King Street Pump Station Improvements (Volume I) & ASR Lime System Improvements (Volume II) - RFCSP

Solicitation Number: CO-00670

ADDENDUM 3

October 19, 2023

SAN ANTONIO WATER SYSTEMS
KING STREET PUMP STATION
IMPROVEMENTS
**NEW CHEMICAL BUILDING
FOUNDATION FRAMING
PLAN**

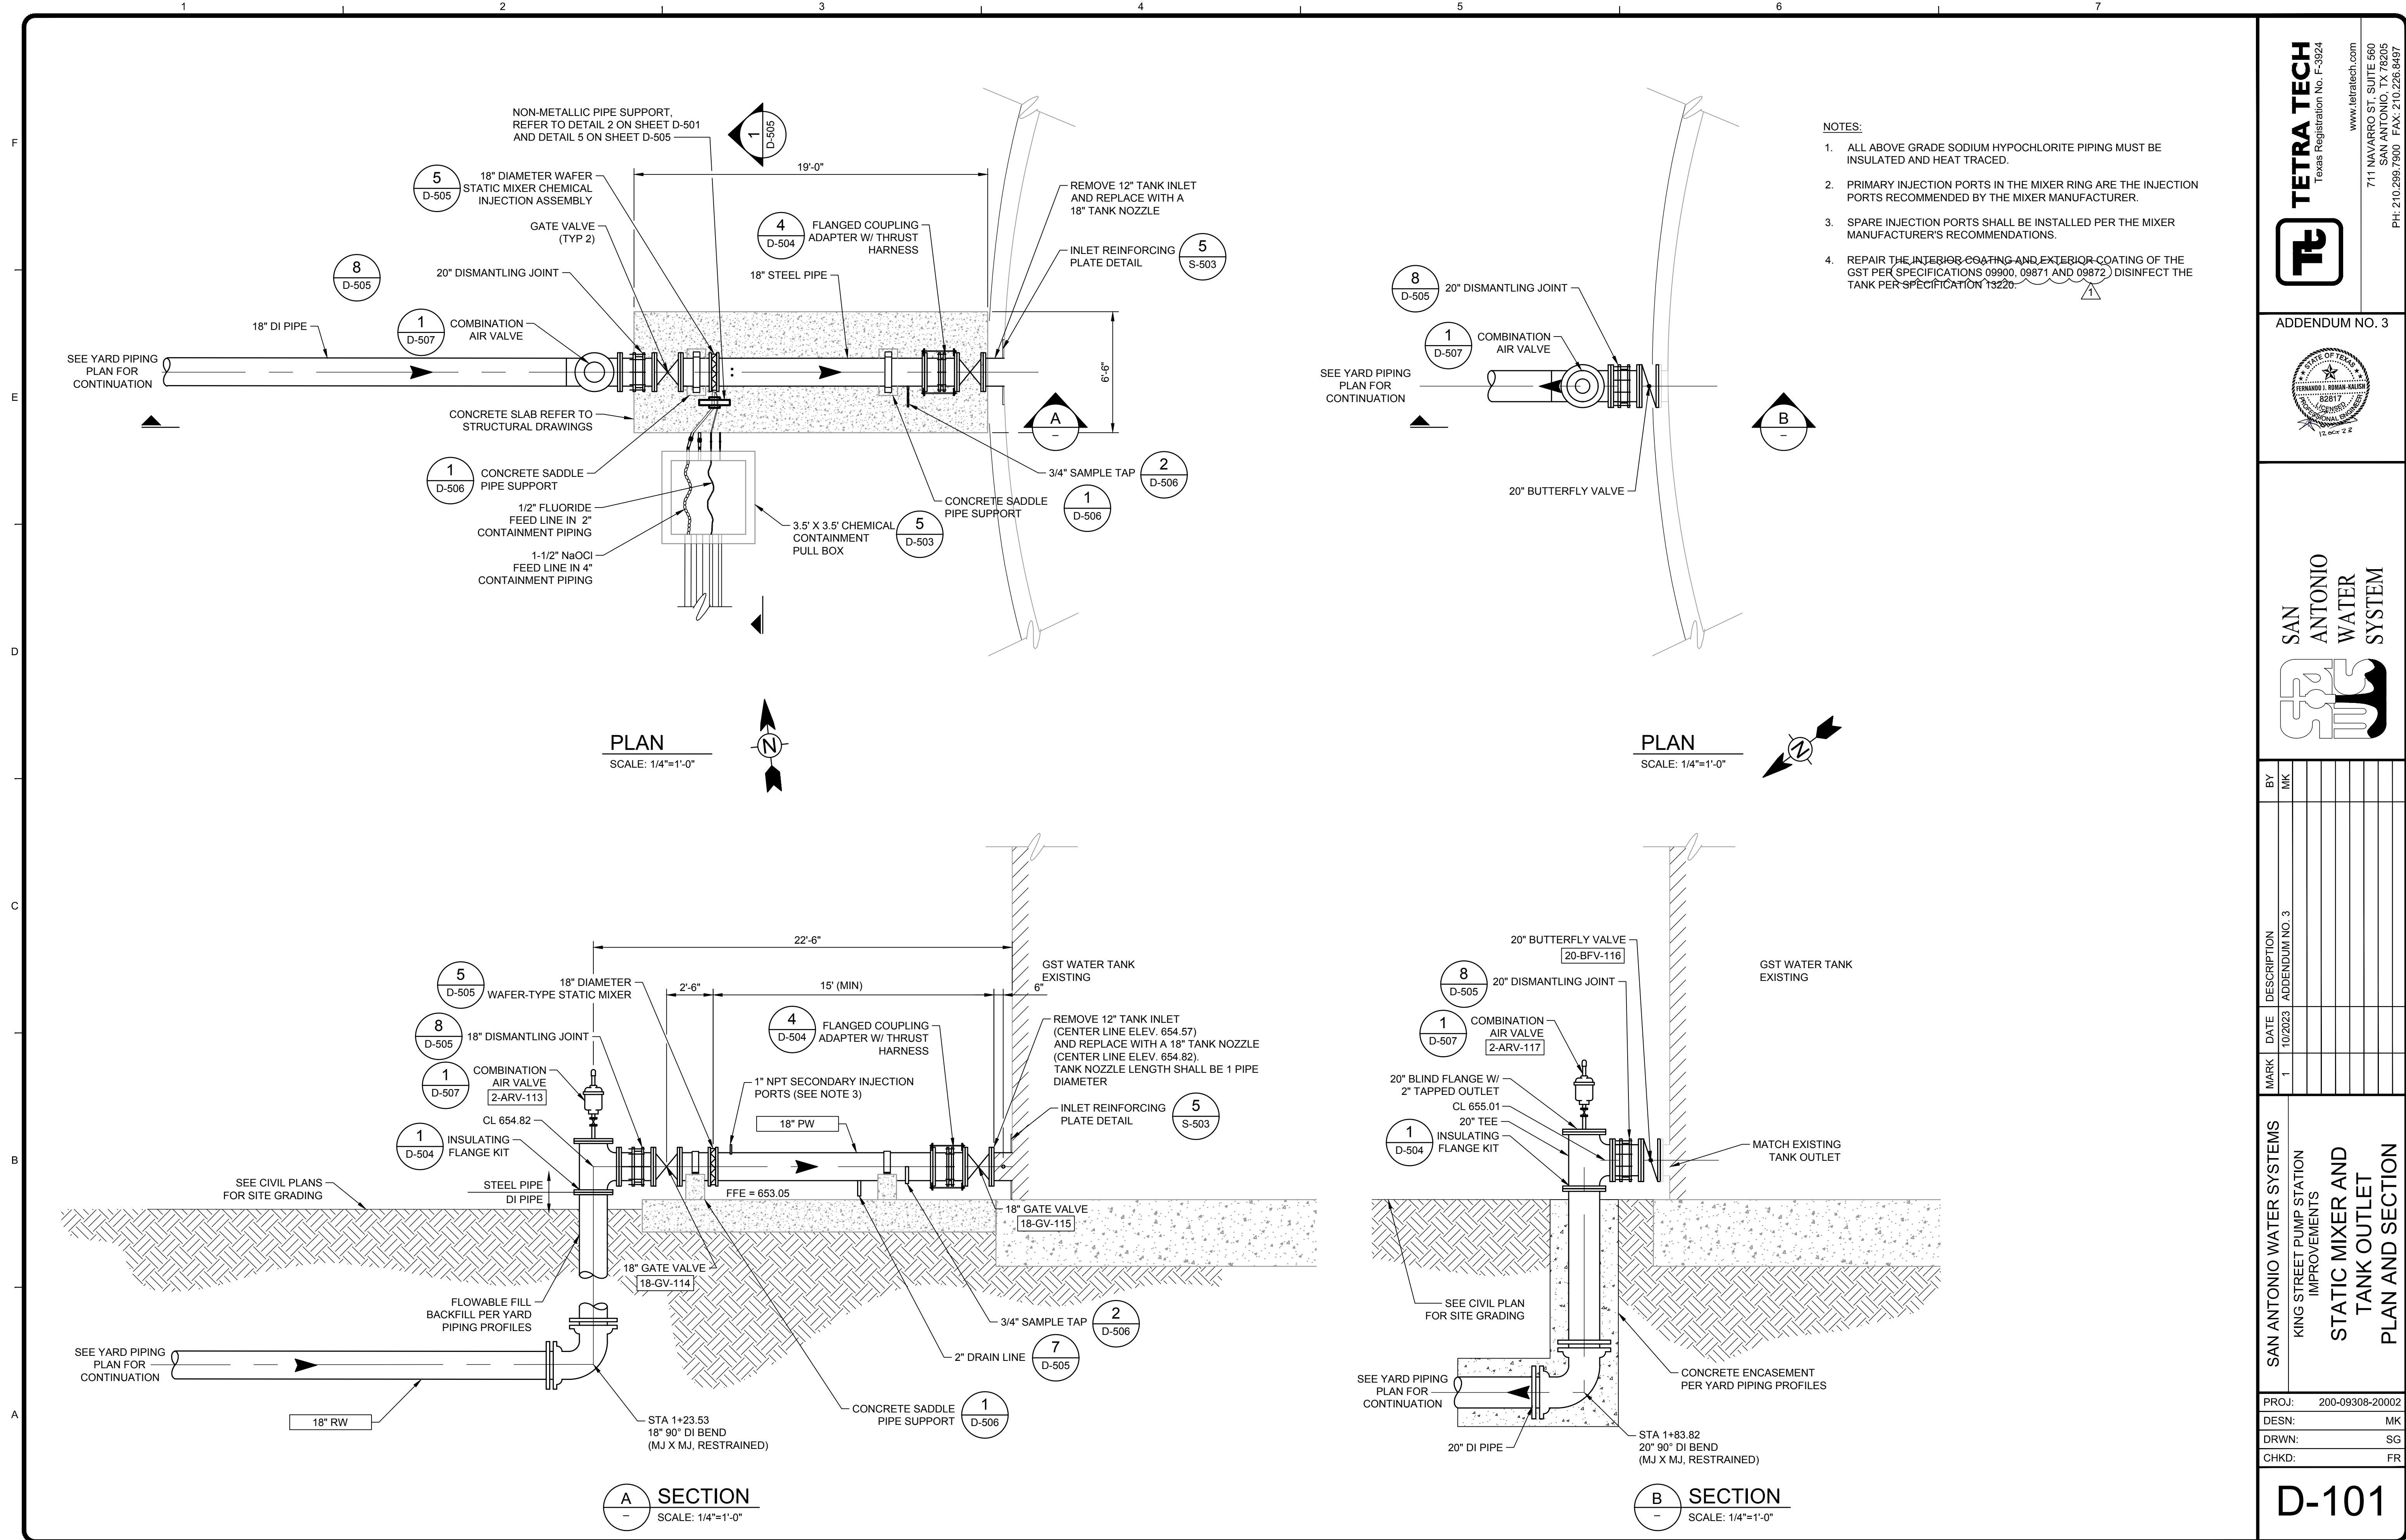
- 3. Question: S-302- The legend on Plan Sheet S-302 indicates aluminum guardrail is "By Others". Please advise if this isn't something you want included with the bid.**

1. DRAWING S-302 – NEW CHEMICAL BUILDING FOUNDATION FRAMING PLAN
 - DELETE in its entirety and REPLACE with the attached.
2. DRAWING D-101 – STATIC MIXER AND TANK OUTLET PLAN AND SECTION

Response: Refer to "Changes to Plans" item No. 1 in this addendum. The handrail shall be provided by the contractor. The handrail design shall be by the handrail manufacturer.

SAN ANTONIO WATER SYSTEMS
KING STREET PUMP STATION
IMPROVEMENTS
**STATIC MIXER AND
TANK OUTLET
PLAN AND SECTION**

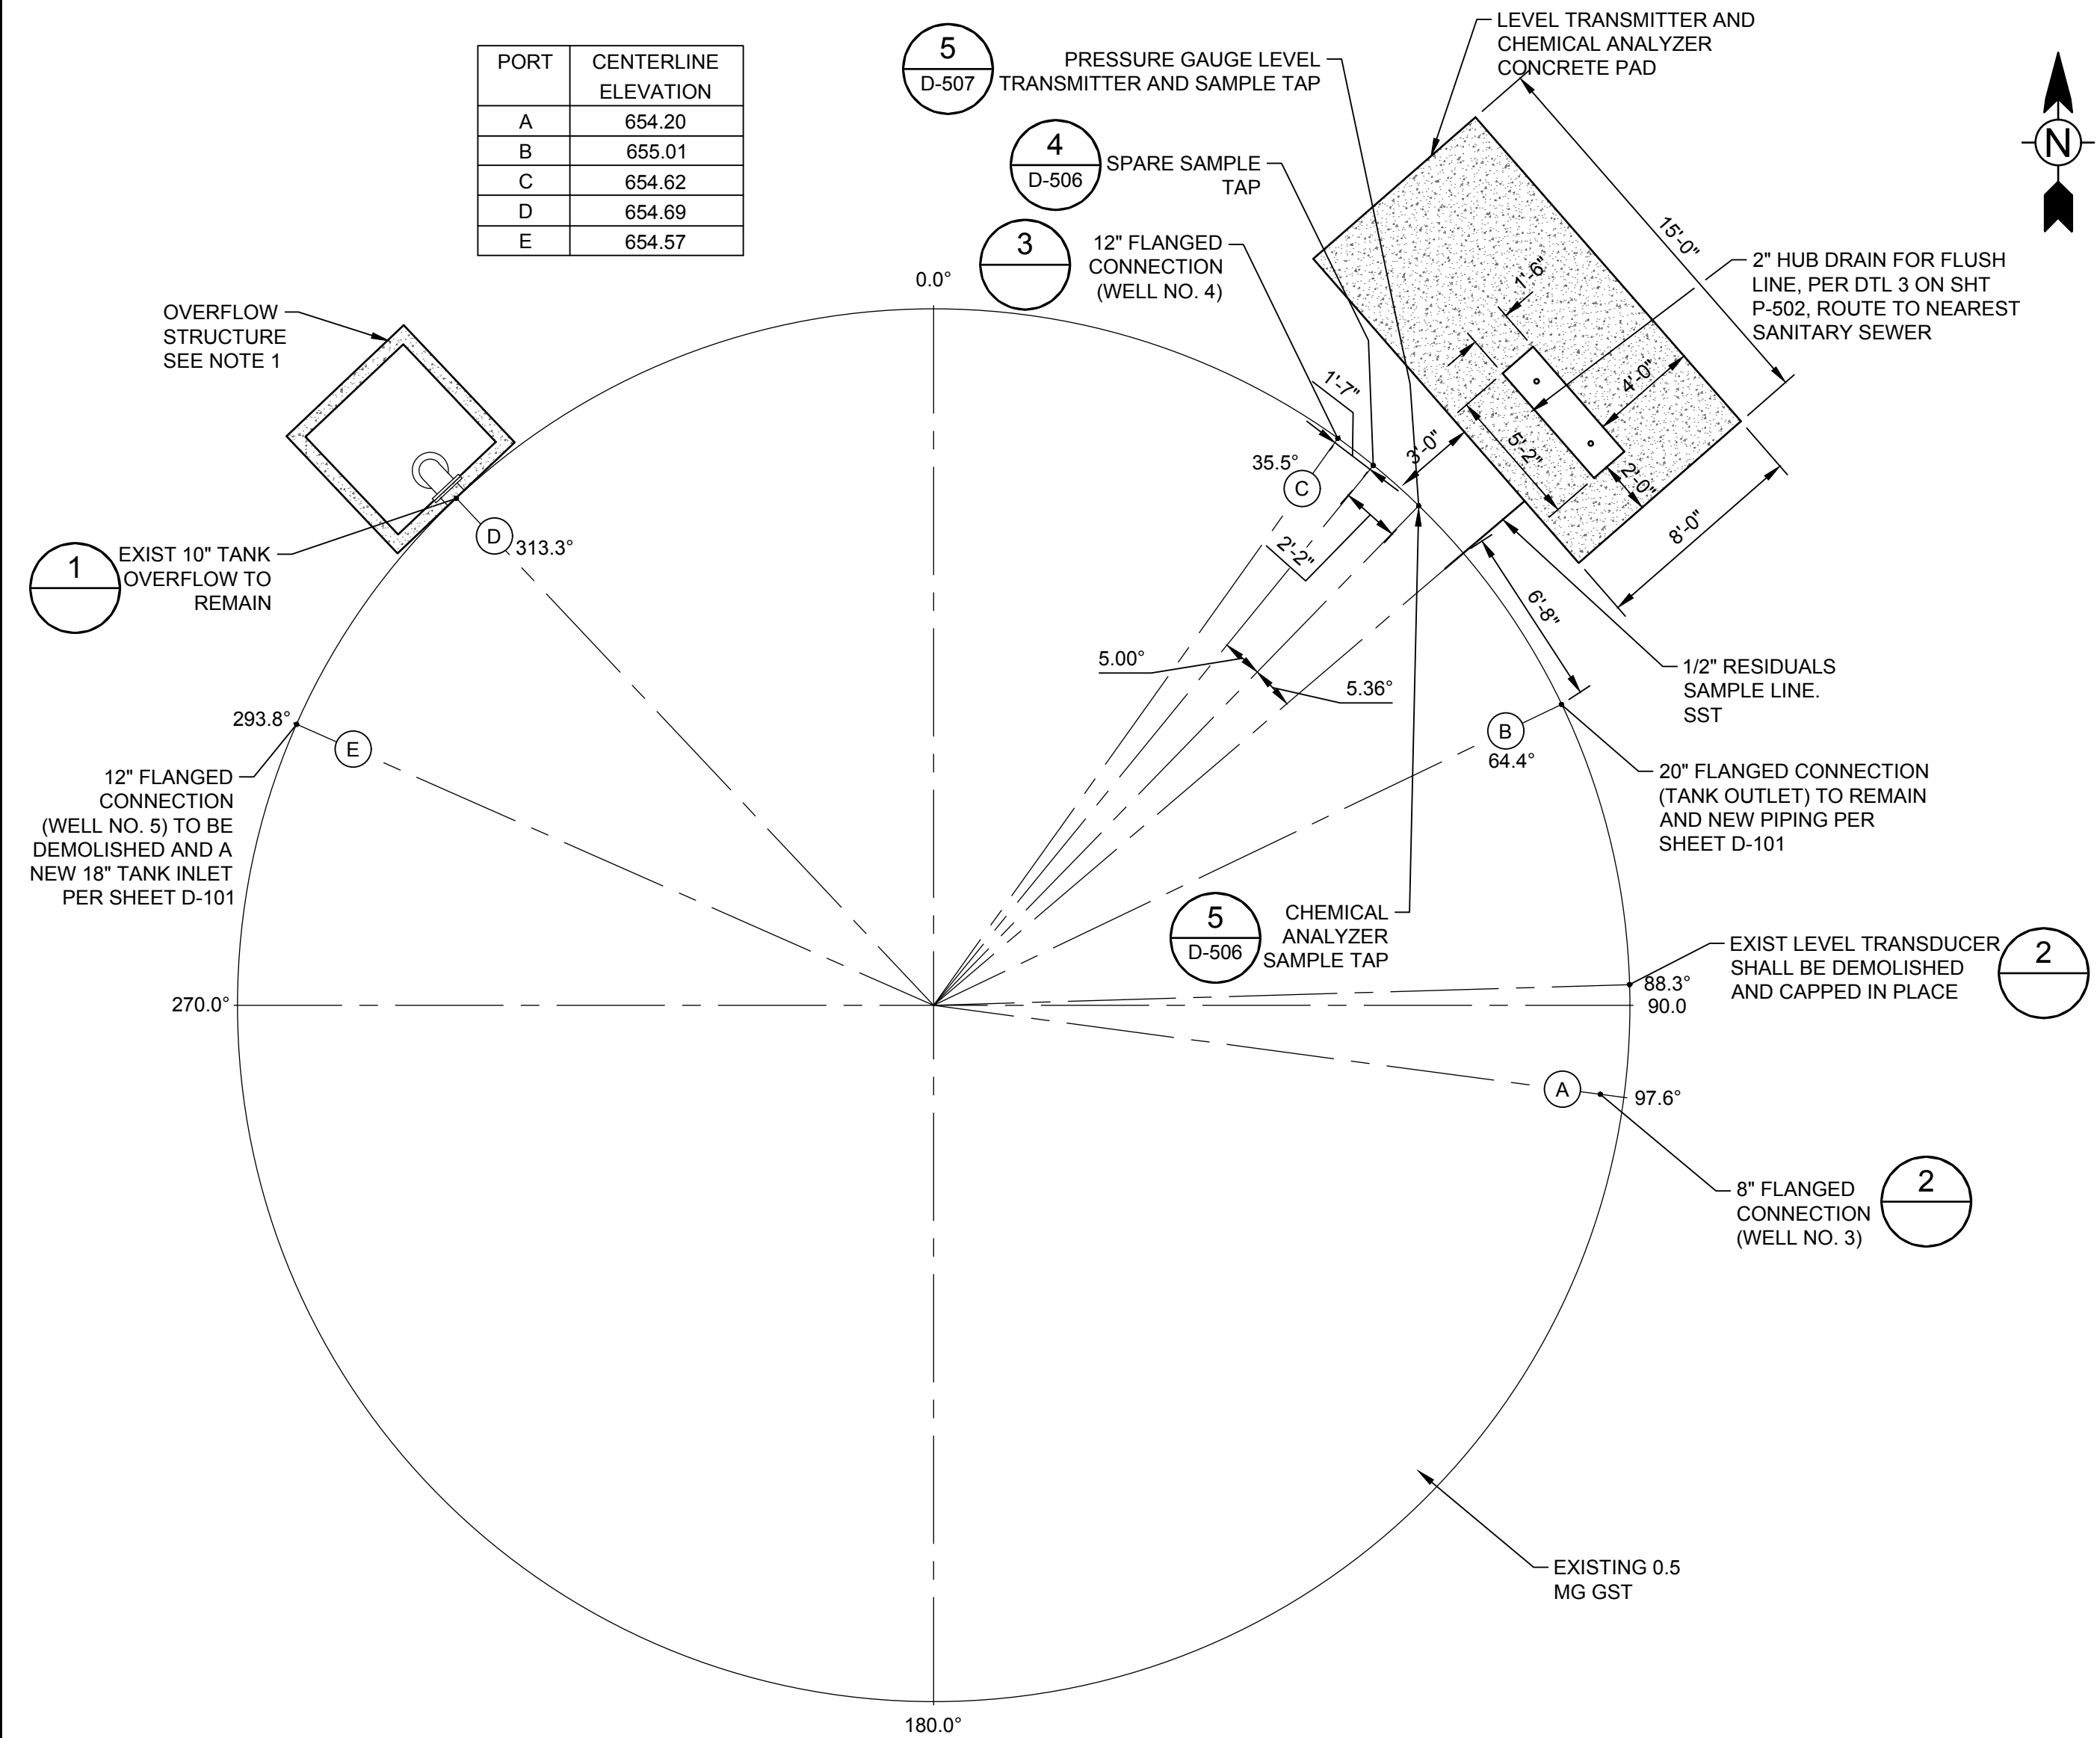
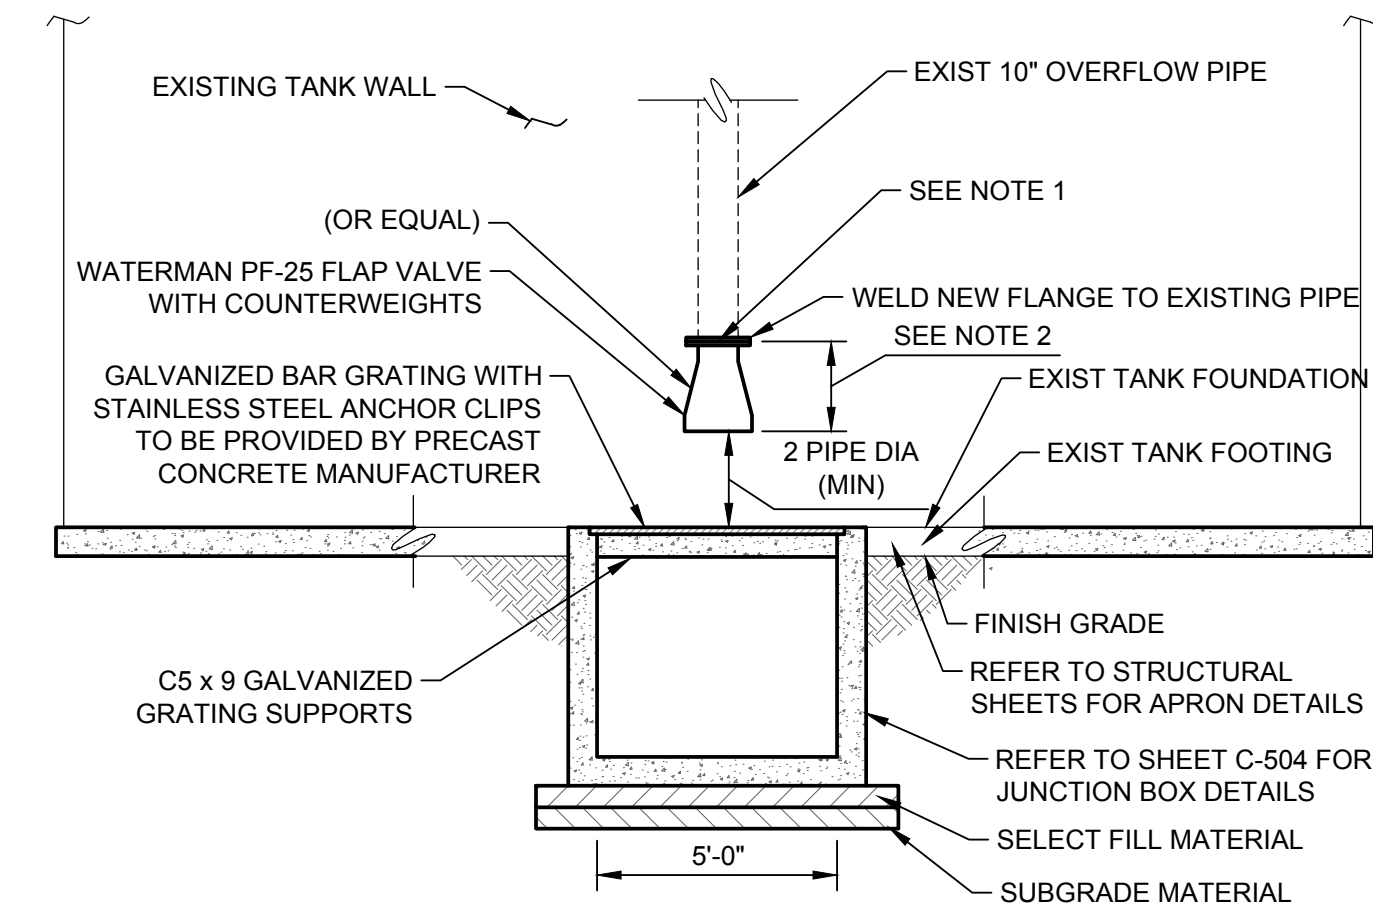
10. **New Pump Station - Drawings D101 & D102 Note 4 states to repair the interior and exterior coating of the existing ground storage tank per 09900. First there is no mention of this in 09900 and secondly, we cannot quantify a sq footage for coating repairs on the tank. Can you either add a bid item with a quantity of sq footage and then clarify what and how the repairs need to be done (prep, coatings etc)?**

Response: Refer to “Changes to Plans” item No. 2 and item No. 3 in this addendum. Interior and exterior coating to be performed as per specification Sections 09871 and 09872 of the contract documents. Drawing D-101 and D-102 refer to the coating damage caused by the demolition and replacement of the inlet nozzle, installation of the inlet reinforcement plate, installation of chemical analyzer sample taps, modifications to the tank overflow pipe, and other work on the tank. The extent of the coating repairs will depend on the means and methods employed by the contractor to accomplish the work and cannot be quantified per sq ft basis. The work is incidental to the tank modifications mentioned above.
